TO: Ryanne Sass, Plaza Street Partners
FROM: Stacey Nerger, Senior Planner
DATE: November 1, 2021
SUBJECT: Lincoln Professional Park – Preliminary Site Plan
Review Comments 01

LINCOLN & DRANSFELDT FILING NO. 1

PRELIMINARY CONCEPT OVERALL SITE PLAN

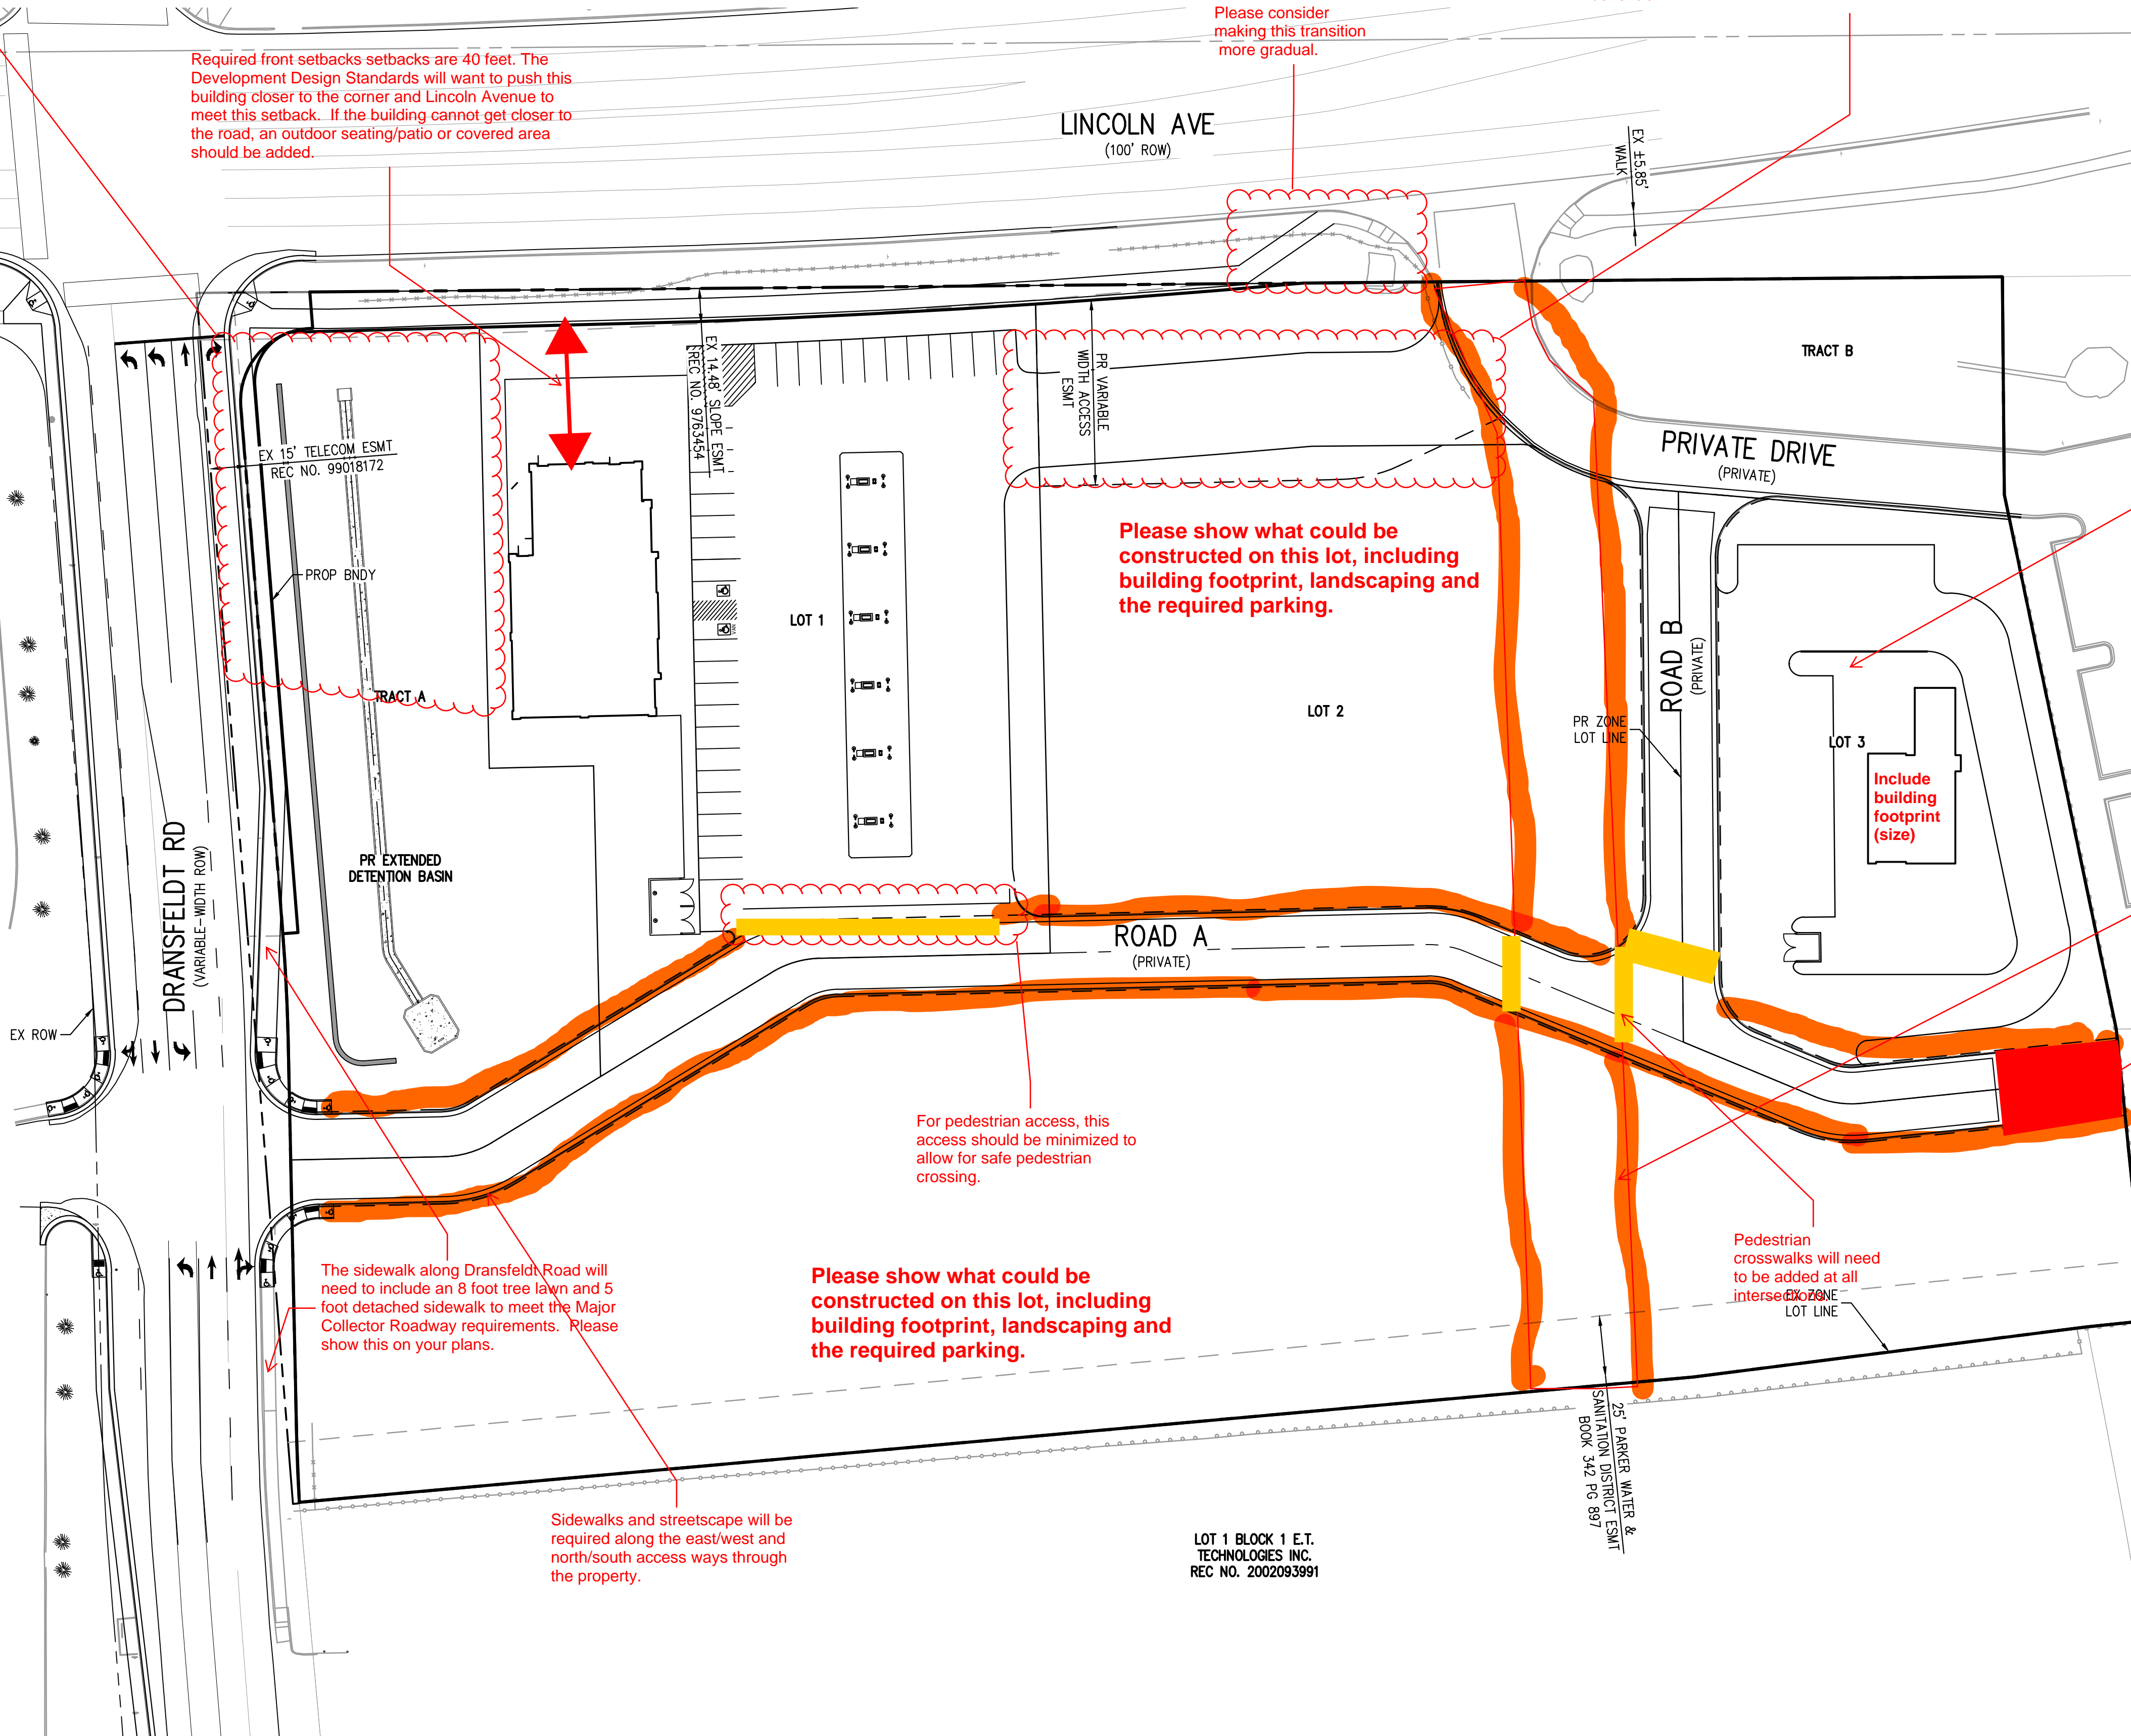
This is a prominent corner for this property/development. Getting the buildings as close to this intersection as possible is preferred. Understanding that this is where the detention pond will need to be located, is there anyway to reduce the size of the pond or narrow the pond at this location to give development the opportunity to get closer to the intersection.

This area is currently proposed to be platted entirely as an access easement. Development cannot occur within the easement. Depending on the layout of the access path, having the ability to have parking and landscaping for the development of Lot 2 north of the access could be beneficial.

Required front setbacks are 40 feet. The Development Design Standards will want to push this building closer to the corner and Lincoln Avenue to meet this setback. If the building cannot get closer to the road, an outdoor seating/patio or covered area should be added.

Please consider making this transition more gradual.

Please show what could be constructed on this lot, including building footprint, landscaping and the required parking.

Show the required parking and landscaping needed to meet this proposed development.

Per the Annexation Agreement for the property. A north/south access easement is required through the property. This should be extended to the southern property line. In addition, understanding that access easement from Lincoln Ave. is owned by Walgreens, can this access be straightened to allow better continuous access through the site without changing Walgreens access.

Continue this east/west connection to the property line.

Pedestrian crosswalks will need to be added at all intersections.

For pedestrian access, this access should be minimized to allow for safe pedestrian crossing.

Please show what could be constructed on this lot, including building footprint, landscaping and the required parking.

The sidewalk along Dransfeldt Road will need to include an 8 foot tree lawn and 5 foot detached sidewalk to meet the Major Collector Roadway requirements. Please show this on your plans.

Sidewalks and streetscape will be required along the east/west and north/south access ways through the property.
